Subject: AP1000 COL Standard Technical Report Submittal of APP-GW-GLN-018, Revision 0

APP-GW-GLN-018, Revision 0
“Alternate Steam & Power Conversion”

TITLE: **ALTERNATE STEAM AND POWER CONVERSION DESIGN**

Alternate Steam and Power Conversion Design

Figure 10A.2-1 (Sheet 1 of 2)

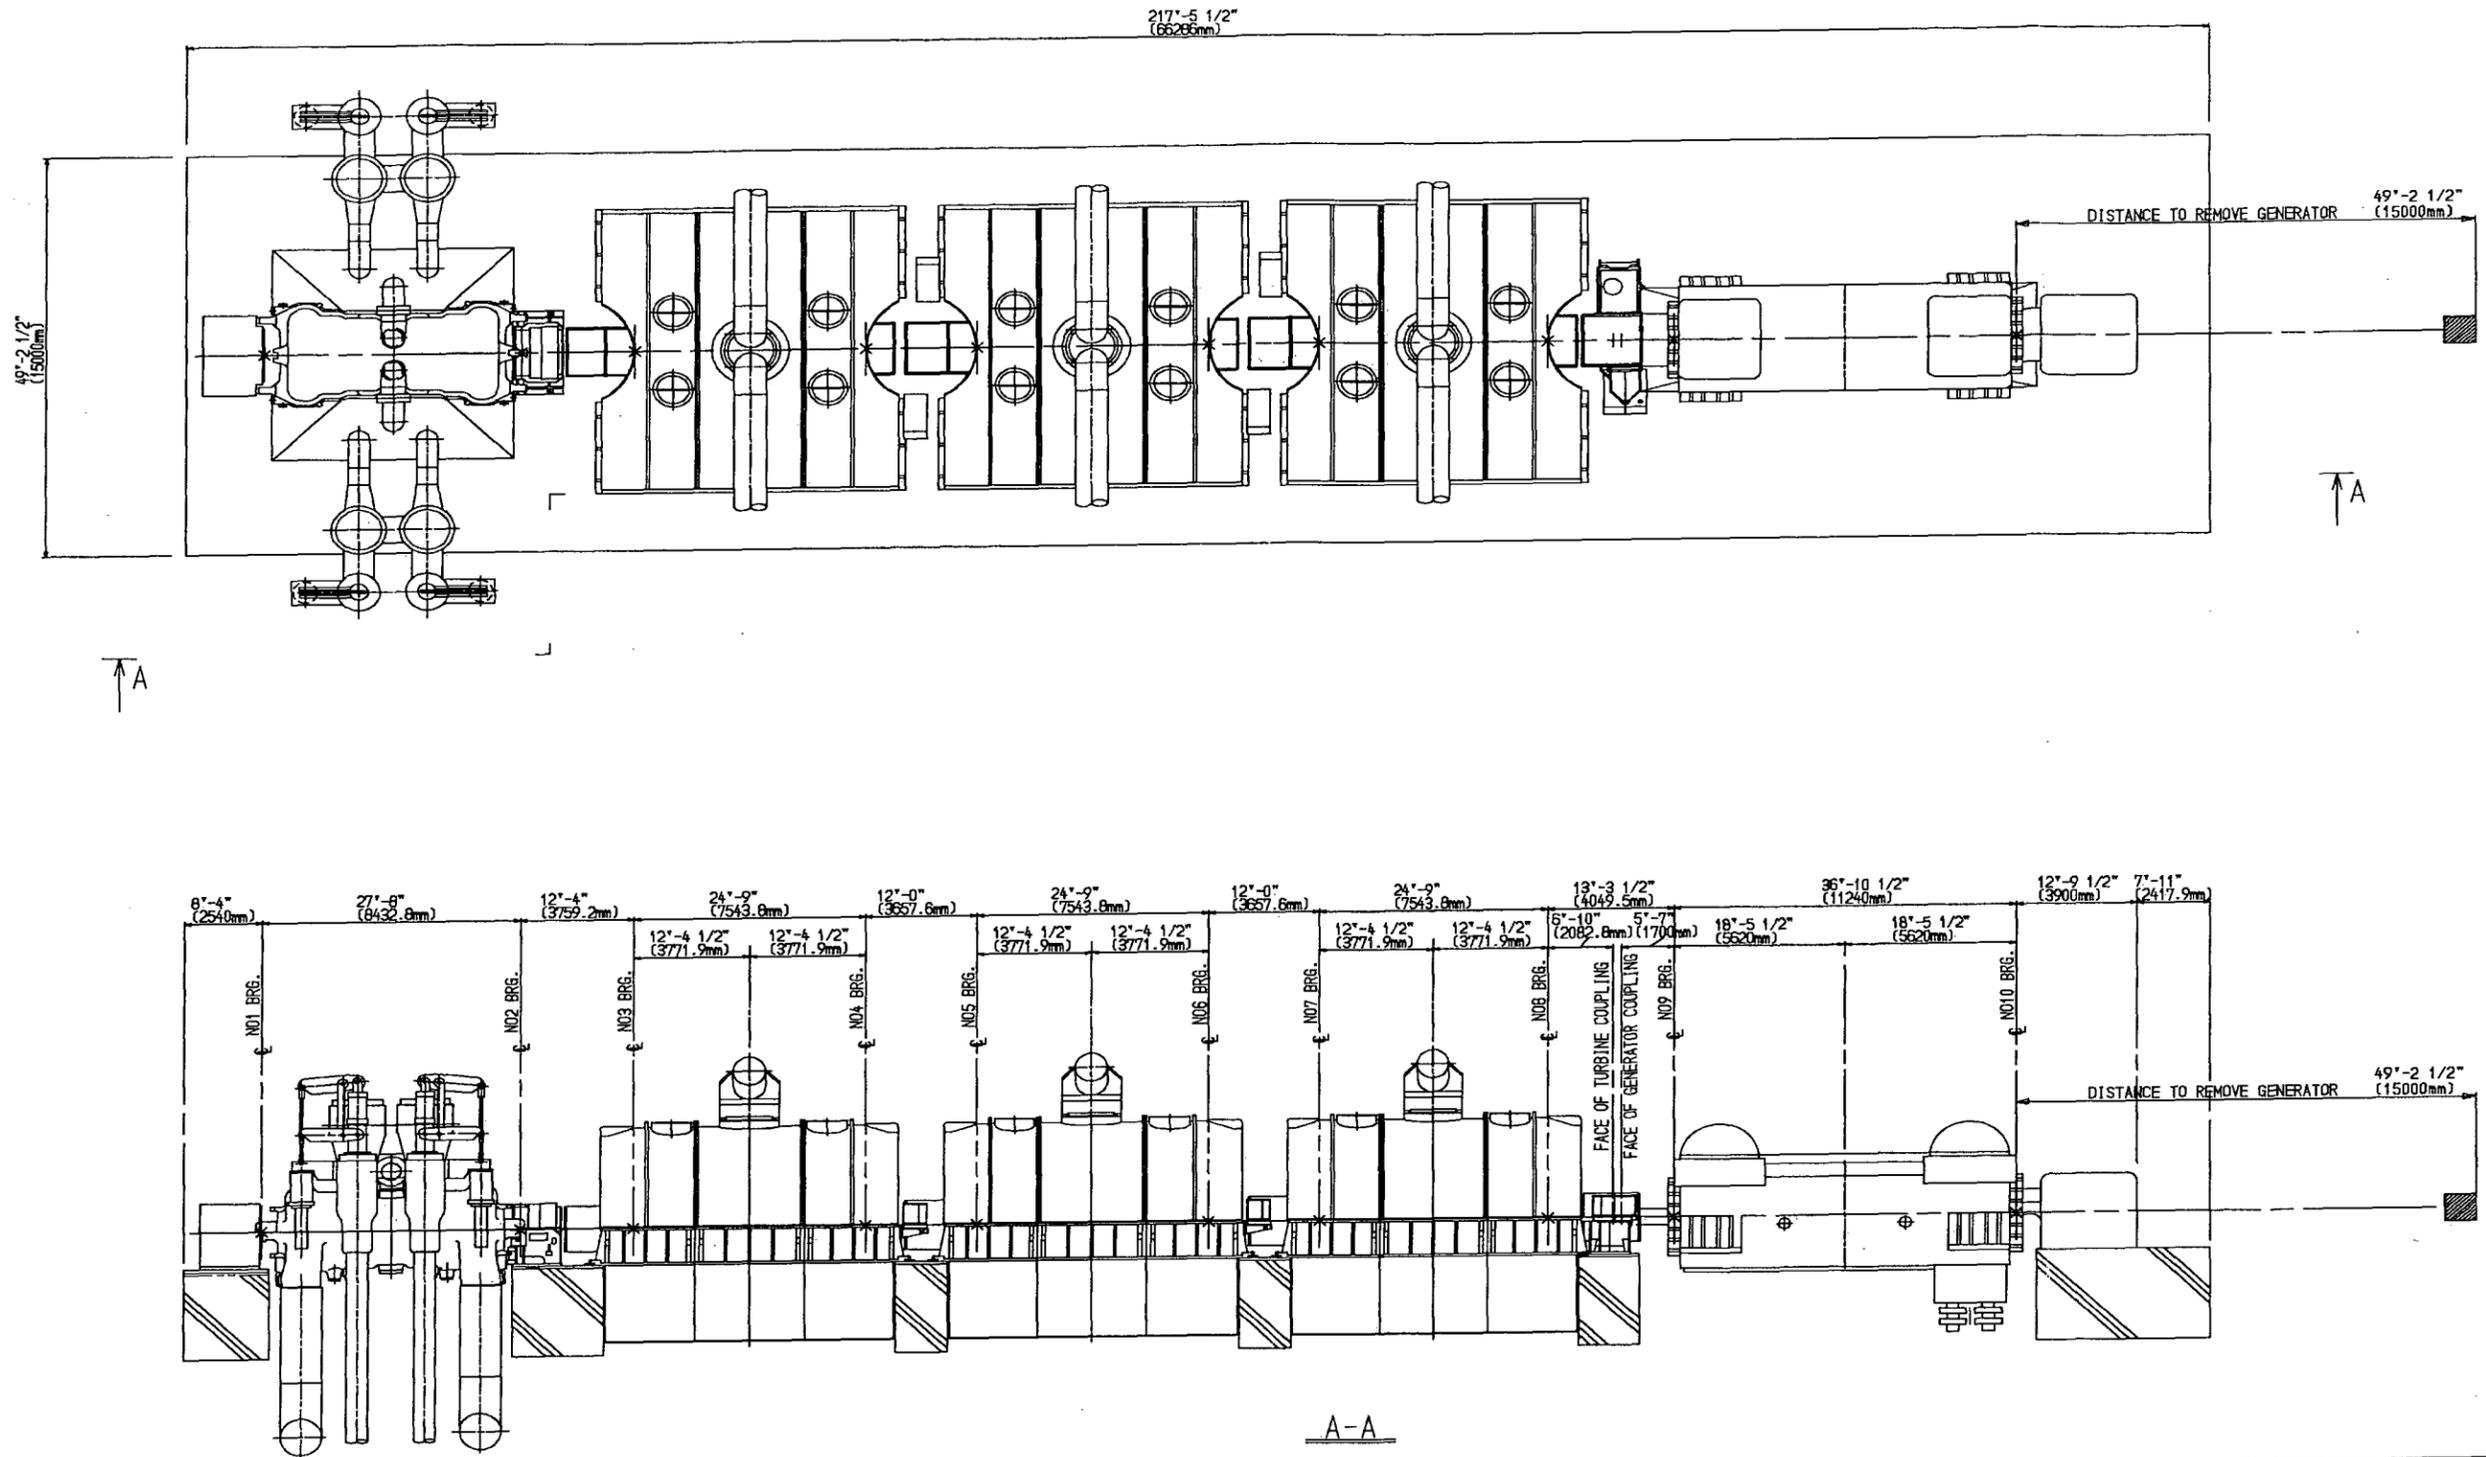
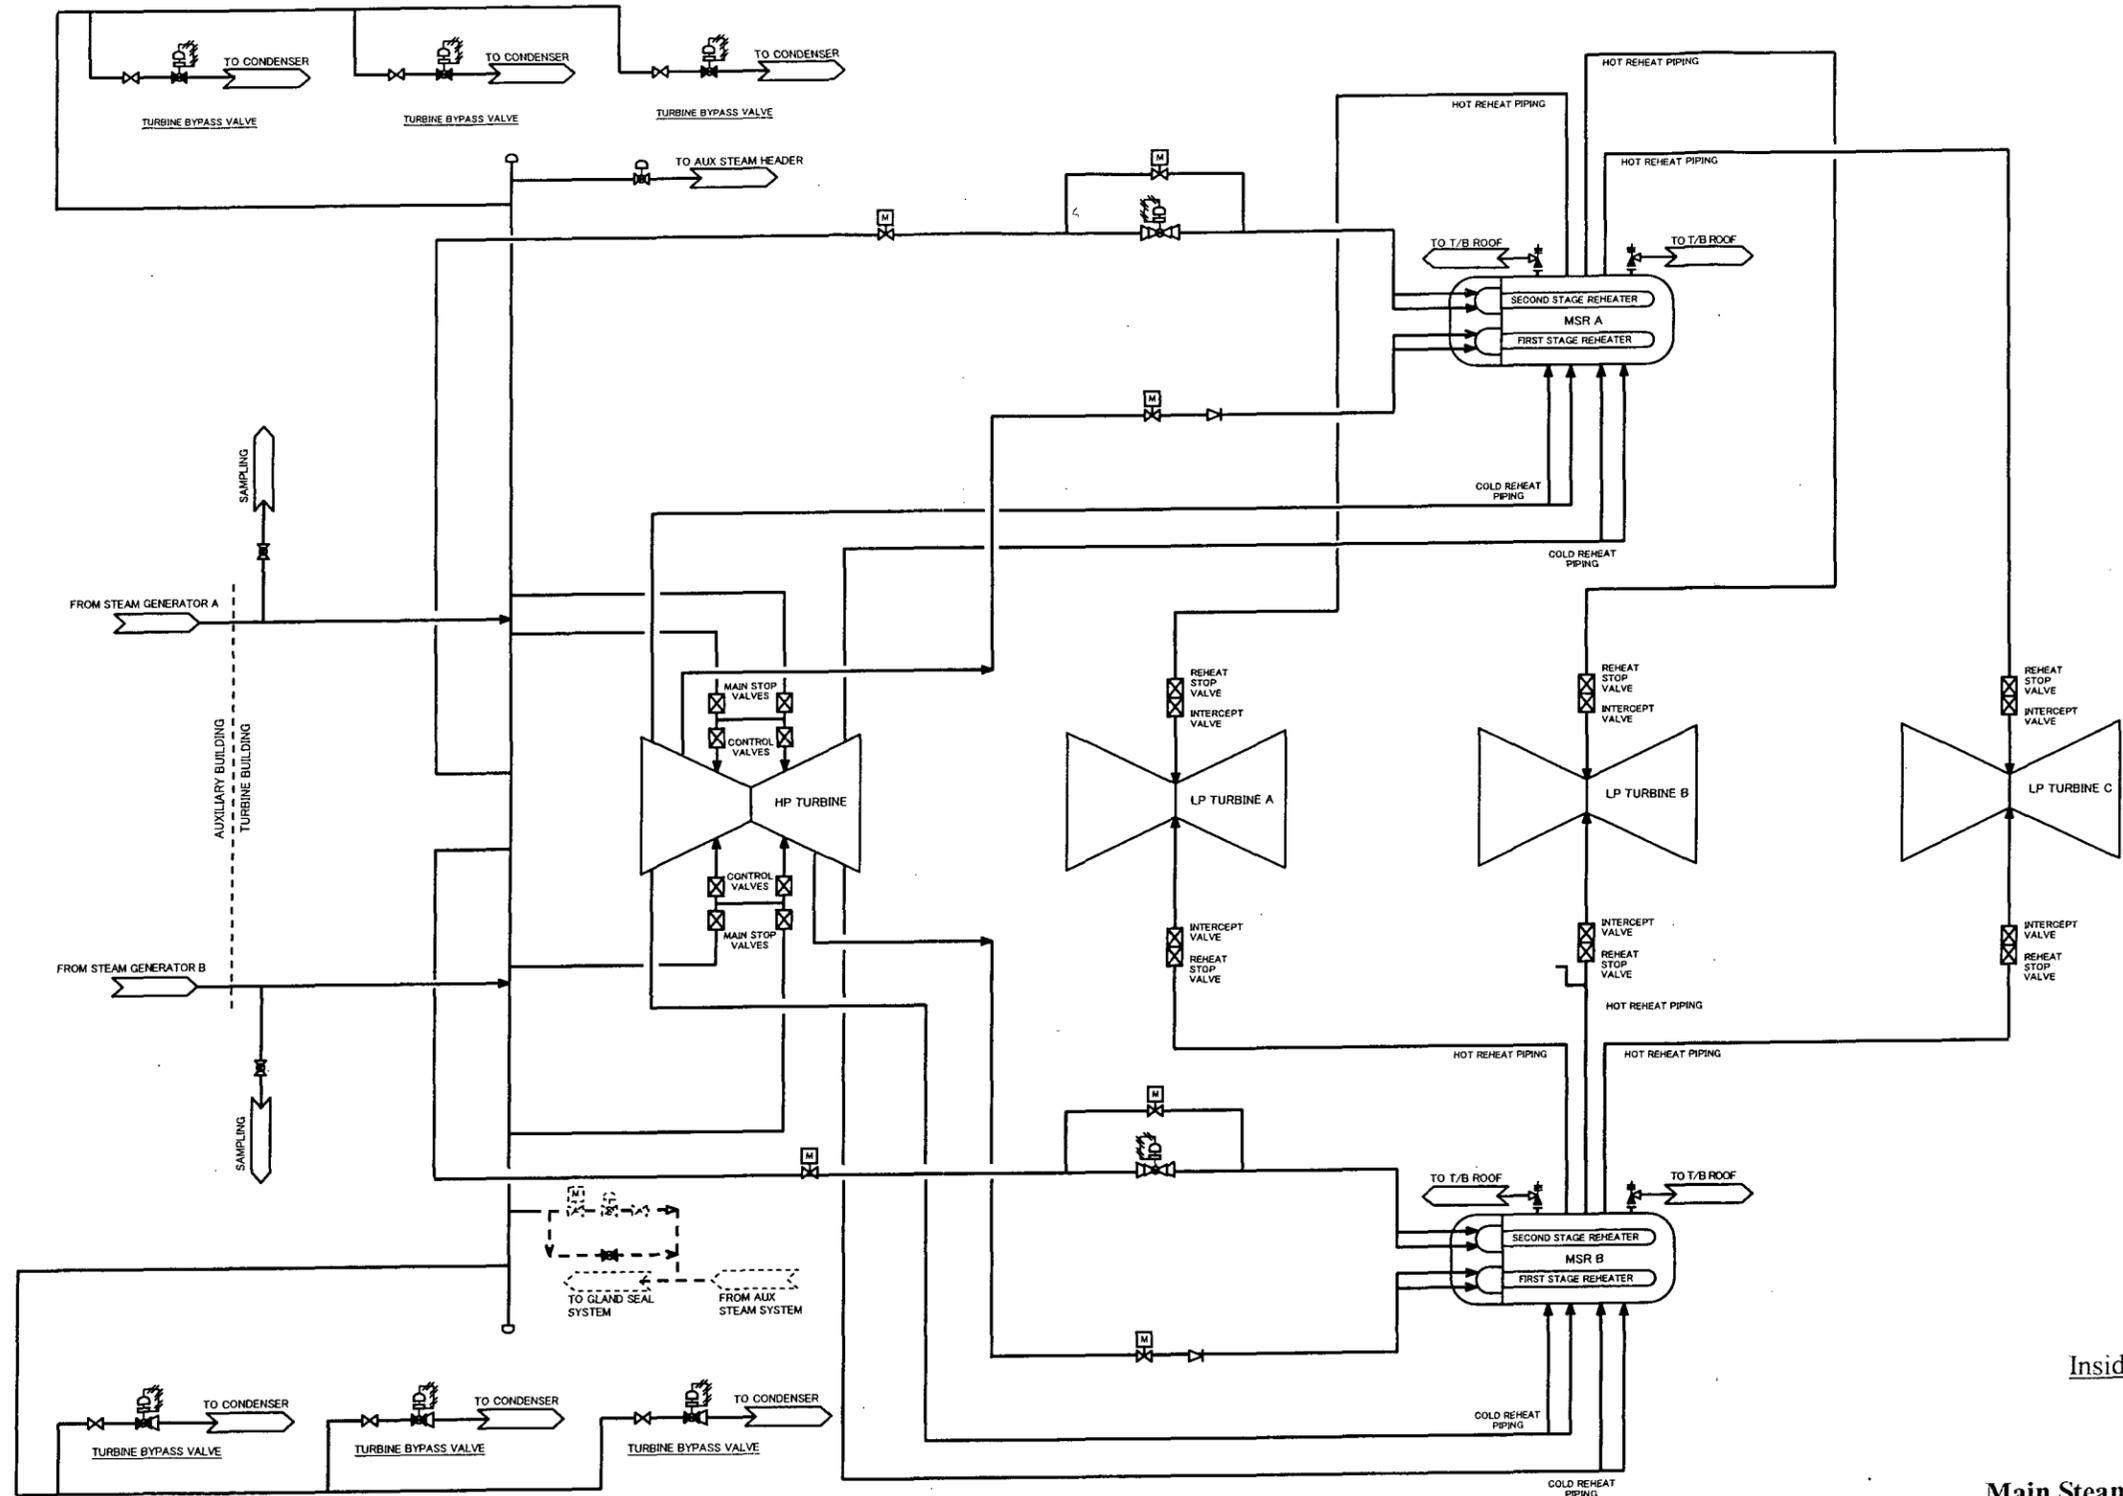
The turbine-generator is designated as a TC6F 52 inch last-stage blade unit~~TC6F 54 inch last-stage blade unit~~ consisting of turbines, a generator, external moisture separator/reheaters, ~~exciter~~, controls, and auxiliary subsystems. (See Figure ~~1010A.2-1~~.) The major design parameters of the turbine-generator and auxiliaries are presented in Table ~~1010A.2-1~~. The piping and instrumentation diagram containing the stop, ~~governing~~ control, intercept, and reheat valves is shown in Figure 10.3.2-2.

Figure 10A.4.3-1
Gland Seal System
Piping and Instrumentation Diagram

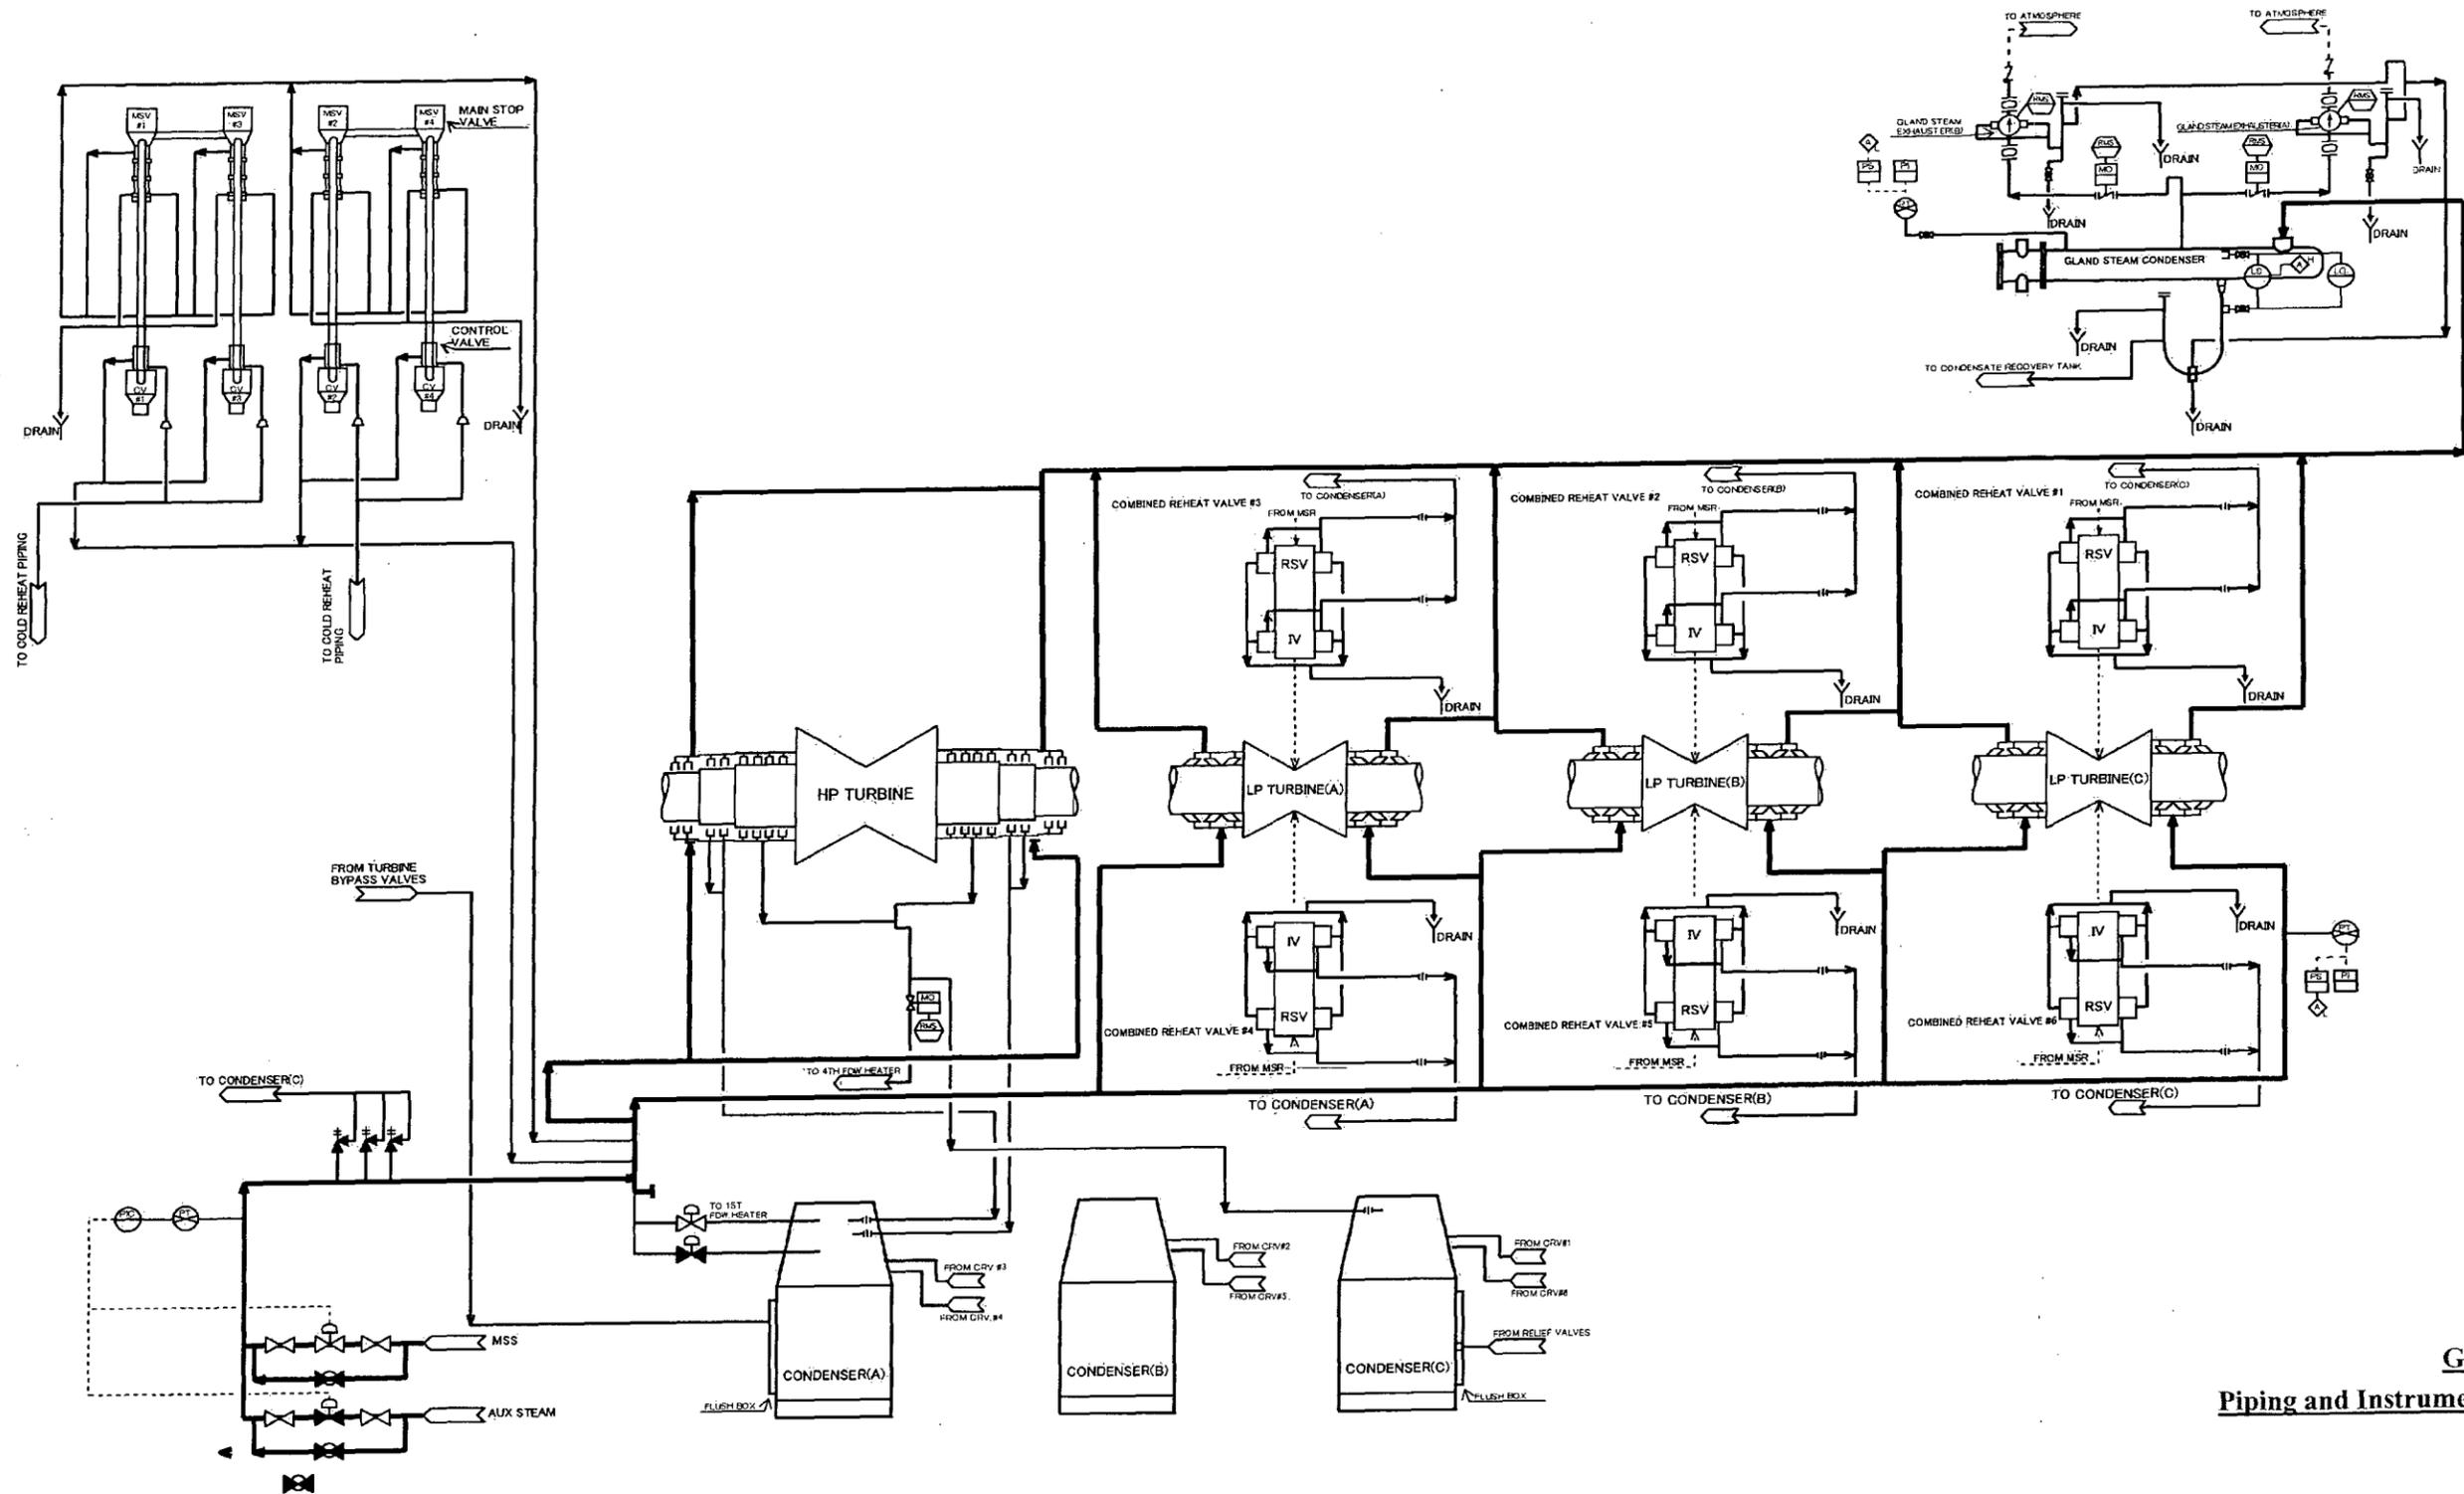
The quality group standards for the gland seal system are provided in Section 3.2. The gland seal system is shown in Figure 1010A.4.3-1.

A pressure controller is provided to maintain the steam-seal supply header pressure by providing signals to the steam-seal feed valve. ~~Pressure control valves are used to provide appropriate pressures to operate both the low and high pressure turbine steam seals. Excess steam flow is handled by the gland spillover control valve which discharges to the No. 1 feedwater heaters.~~
